MIP 14-08

5651 Cascade Street Partition

TENATIVE PLAN
CASCADE PARTITION

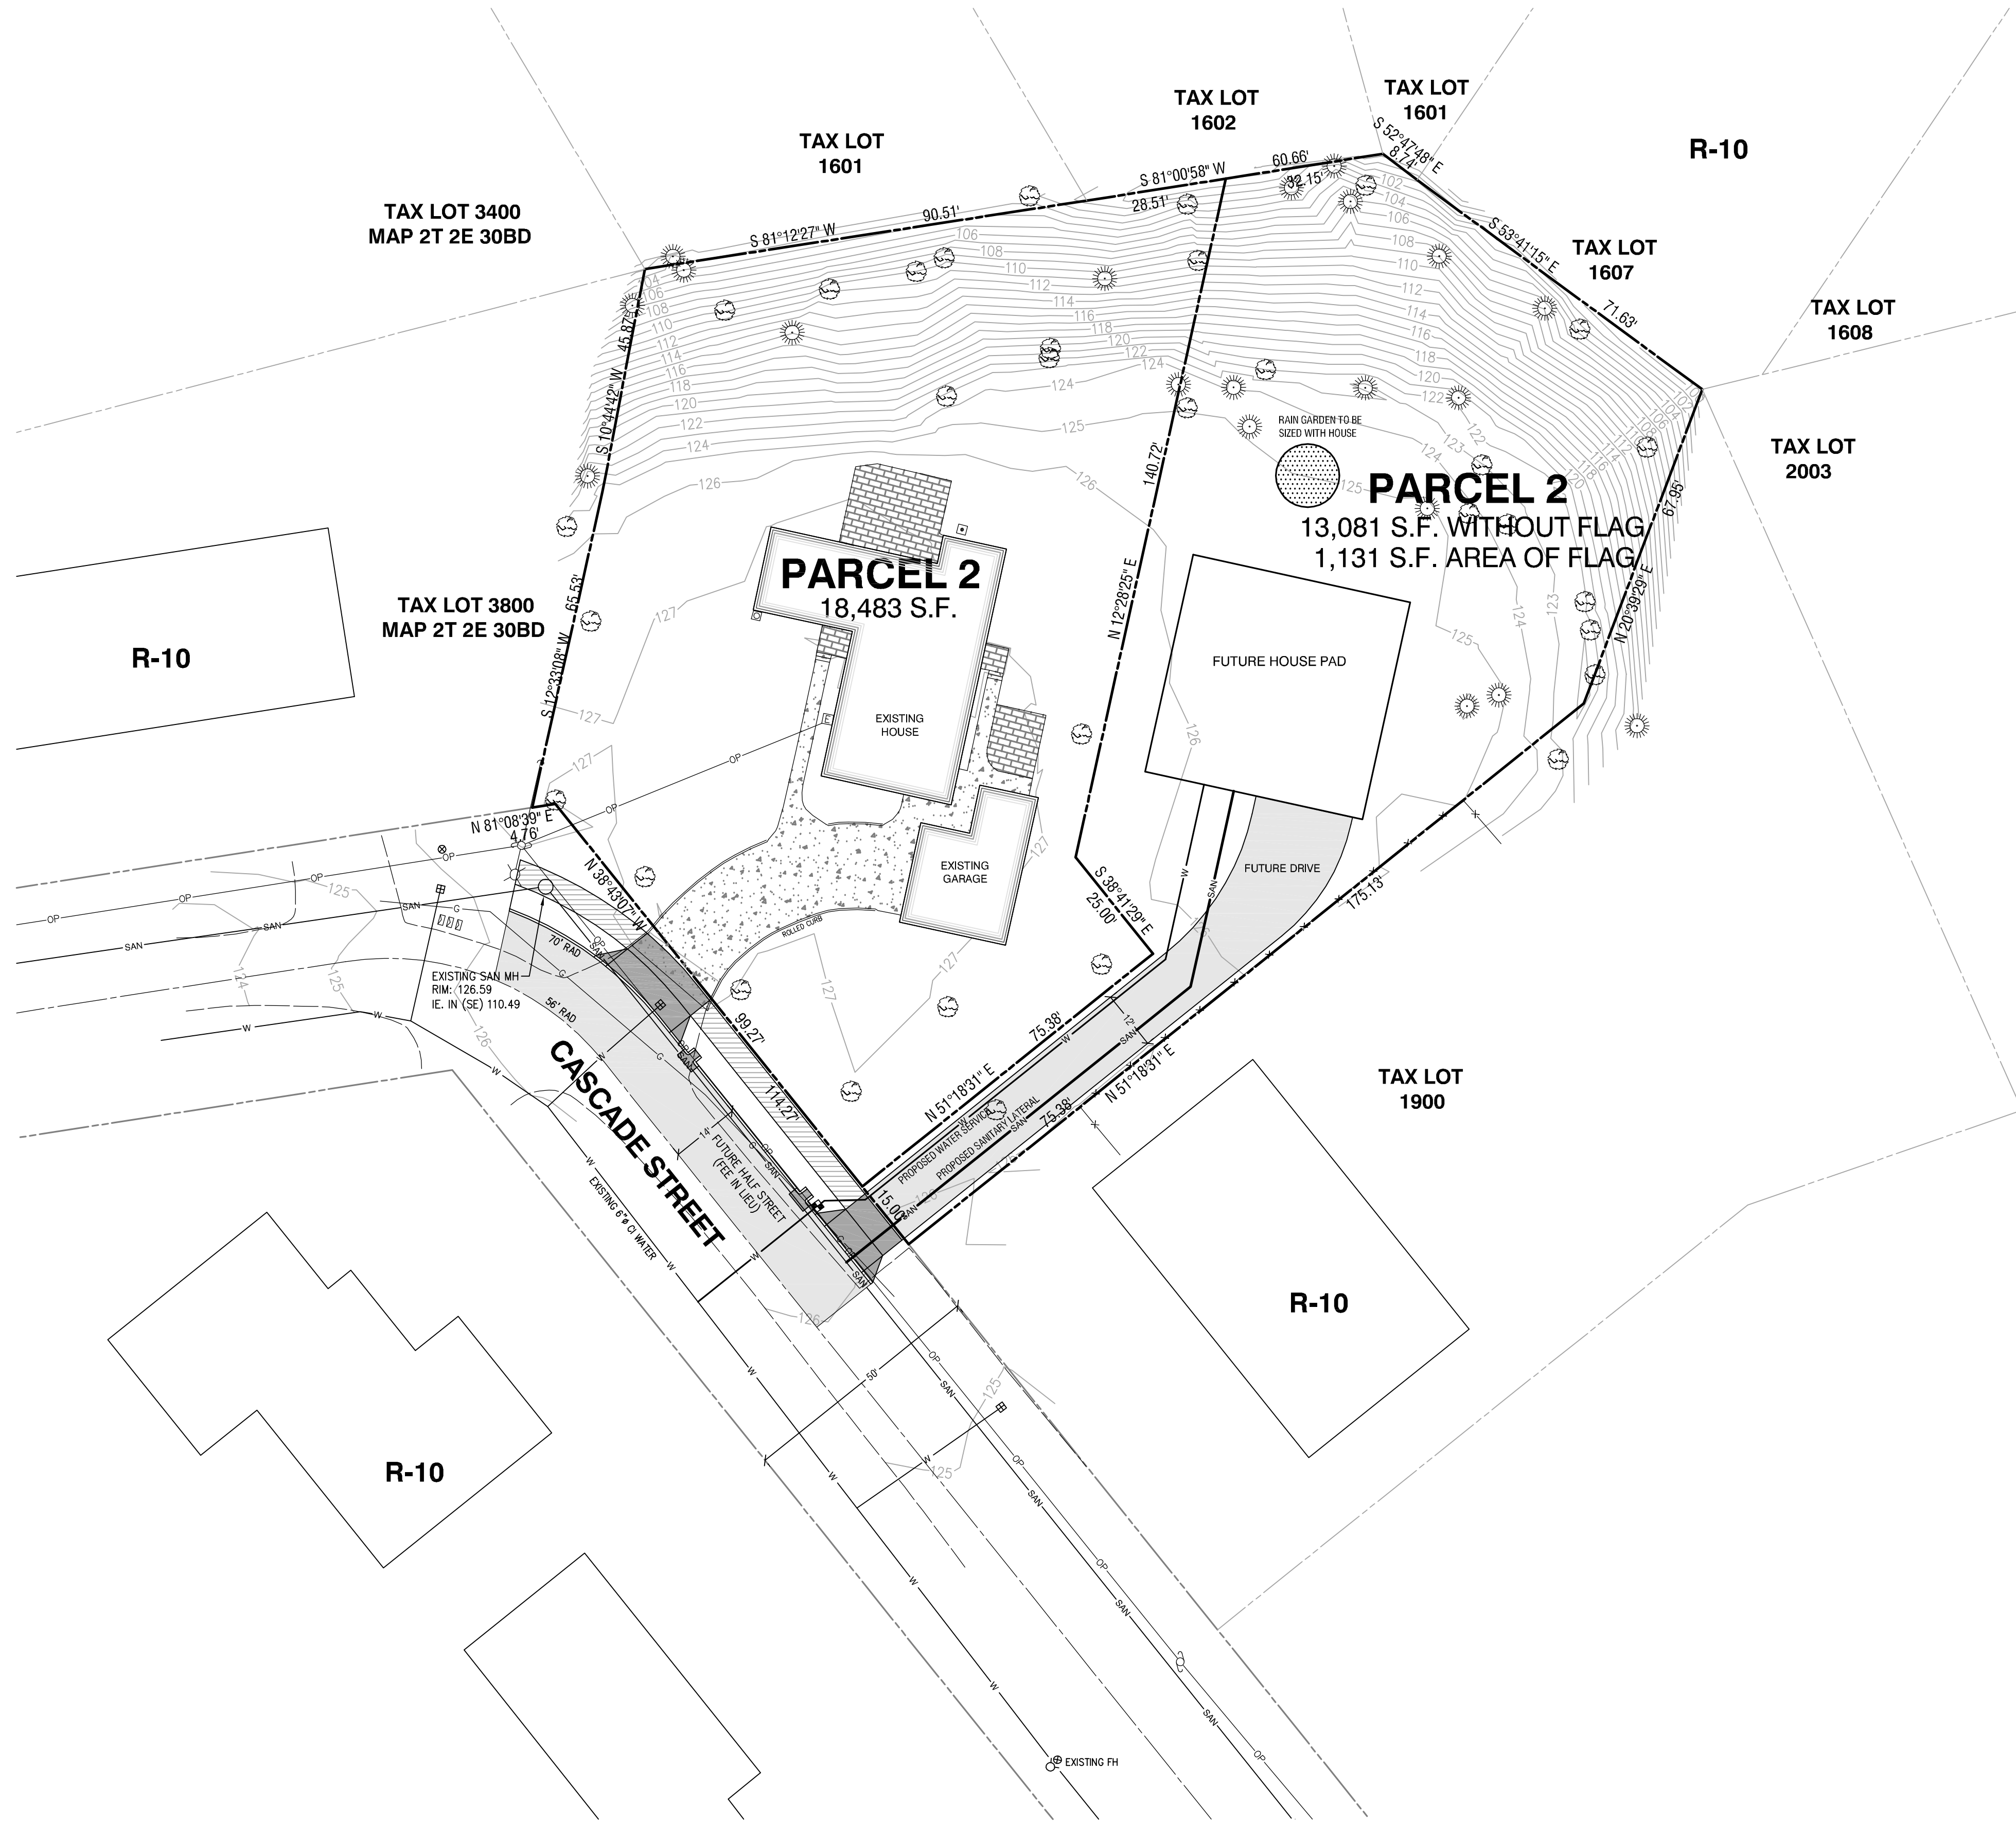
- A. Corrections have been made to the tentative plans: a bar scale has been provided, the widths of existing streets has been shown, outlines of adjacent houses provided.

- B. Plans were provided to the City Arborist and Mike Perkins response is that he is satisfied with the plan.
- C. 24.070 Exemptions from planned unit development requirements: Under item B no development, construction or grading will take place on Type I and II lands. This area has been outlined with a proposed easement to preclude any development that included all the slopes over 25%.

- D. 85.160(F)(2) Erosion Control: No street improvements are proposed. A gravel entry will be shown with the building permit together with silt fencing with the actual building permit following the requirements of Clackamas Counties "Erosion/ Sedimentation Control Plans Technical Guidance Handbook" The building area is nearly level and therefore little potential for erosion control problems.

- E. 85.160(F)(7) Street Trees: A waiver is requested for street trees because a fee in lieu is also being requested for the half street improvements. Additionally there are existing trees adjacent to the right-of-way that will remain.

- F. 85.170 Supplemental Submittal Requirements for Tentative Subdivision or Partition Plat: All the necessary public water and sanitary are found along the frontage of this property and have sufficient capacity for this two lot partition. The requested fire flow by TVFR will be deferred to the building permit phase.

- G. 85.200(A) Approval Criteria - Streets: Cascade Street is a street without walks or curbs throughout its length. A half street section has been shown on the plans but it is requested that a fee in lieu be permitted. The character of the area would be changed if half street improvements were required on this short section of the street. The Street is without a public storm system and even with swales adjacent to the curb storm water would be concentrated with no overflow connection. No new streets are proposed and only one new single driveway will be constructed with this plan.
